ABSOLUTION OF QUERY LIST

UNFPA/PER/RFP/001/2021

EXECUTION OF WORKS FOR REMODELING THE UNFPA PERU OFFICES

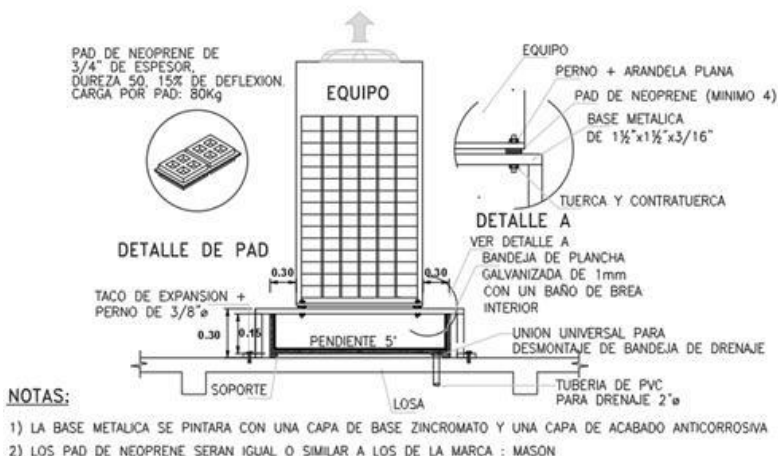
Query: Indicate detail of antivibration base for VRF condensing units.

Below is the installation detail. The neoprene pad works as an antivibration support for the base of the VRF, in its metallic structure.

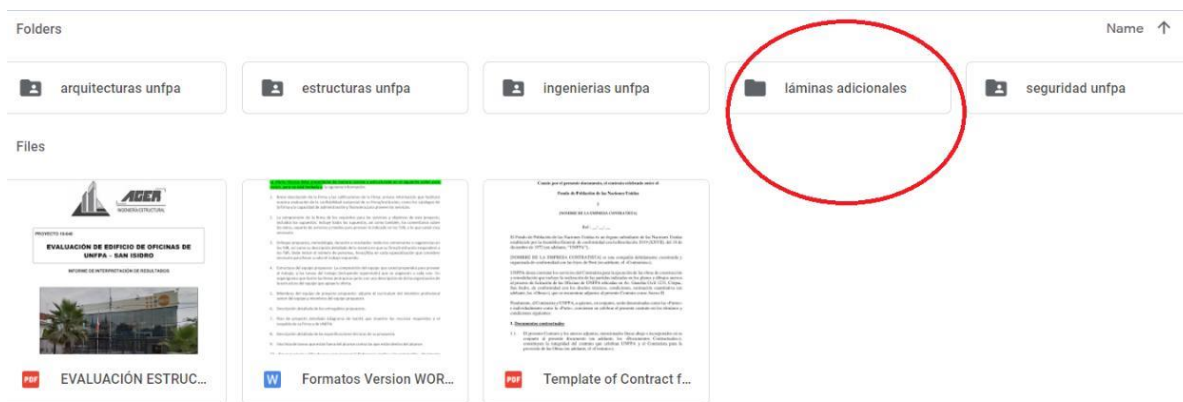
Query: Regarding Sheet A03 and A04, the hatching does not indicate which demolition it refers to. Clarify that the diagonal hatched lines are demolished. It does not specify which floors exist, to determine areas of each floor.

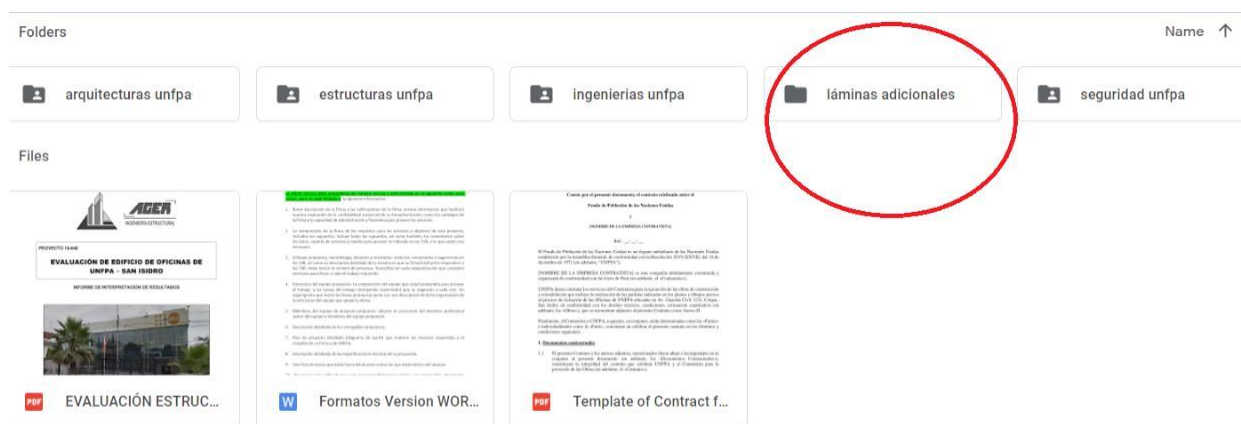
Query: It is indicated that the basement will be intervened, however, the resulting plan for Basement Architecture has not been attached.

The resulting floor plan of the basement is attached. To download it you must access the link for the Technical File.

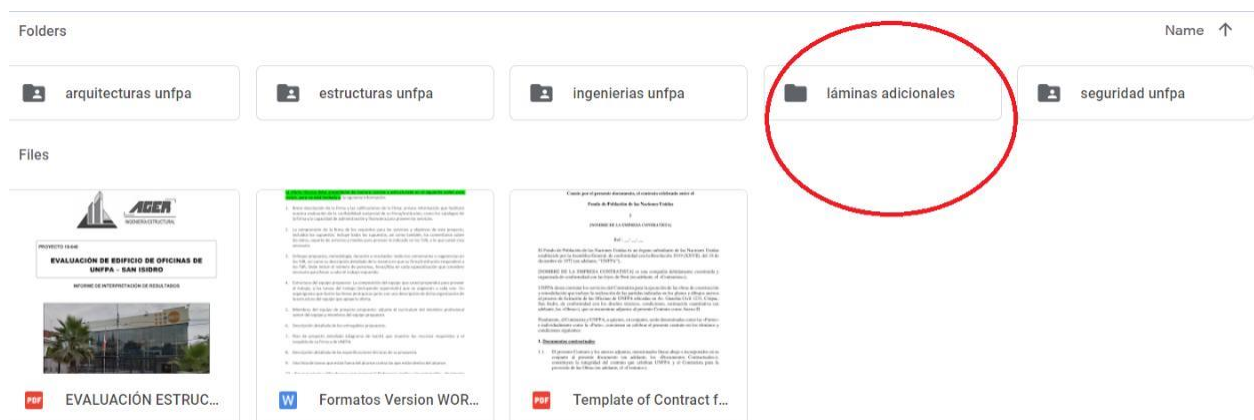
Query: Item 03.08.05 and plan D.007, what type of finish should be considered?

The distance between 3/8" stainless steel rods does not comply with what is indicated in the RNE, how should it be considered? Detail 1 indicated in Section 2-2 of plane D.007 is not found on the sheet, clarify.

Railings are polished stainless steel. Plan with corrected detail according to RNE and Plan D007 including detail 1 is attached. To download them, you must access the link of the technical file.

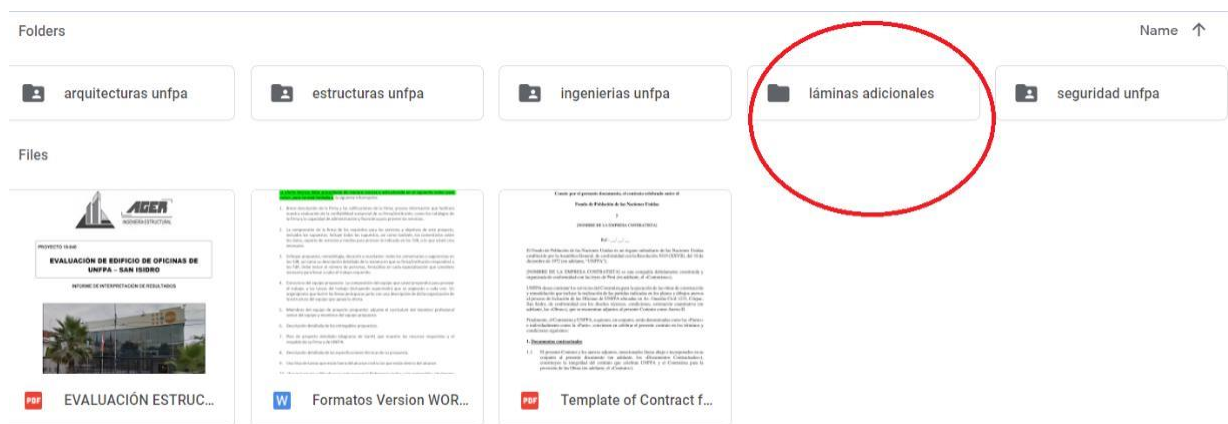
Query: In Plan A006, disabled bathroom, the width of the door does not comply with Standard A 120 - Art.13. Clarify.

Corrected Plan A006 Distribution 1 floor and plan D001 Detail of Doors and Windows are attached, where the door width is corrected to 90 CM. To download, you must access the link of the technical file: <https://drive.google.com/drive/folders/1Erk10IaxZBR0DEVBUcXWMQbNvX9datcv?usp=sharing>

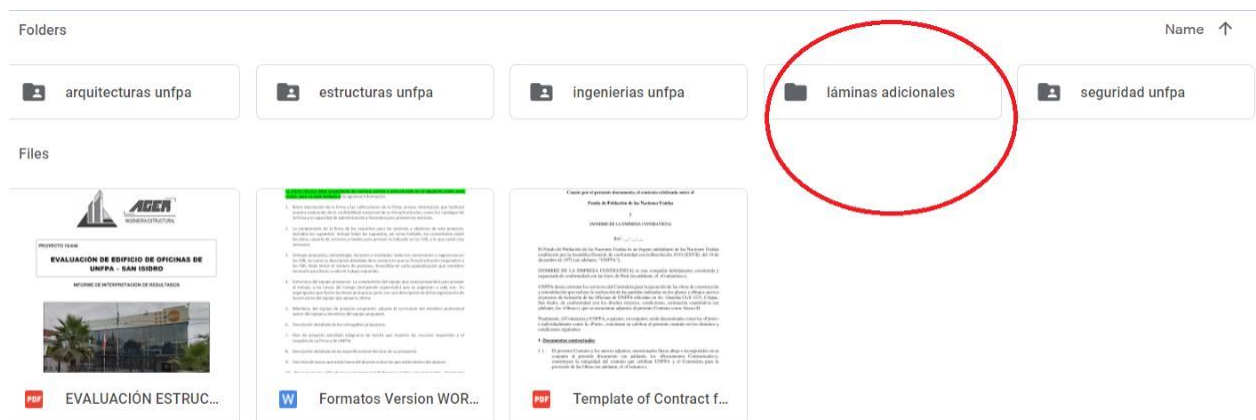
Query: In Plan A.008 a tongue-and-groove ceiling is indicated in the kitchenet - dining room area and in Plan A.020 it is indicated a Light Polycarbonate Ceiling with Black Aluminum. Which one should be considered?

The A008 must be considered correct. Corrected Plan A020 is attached. To download, you must access the link of the technical file.
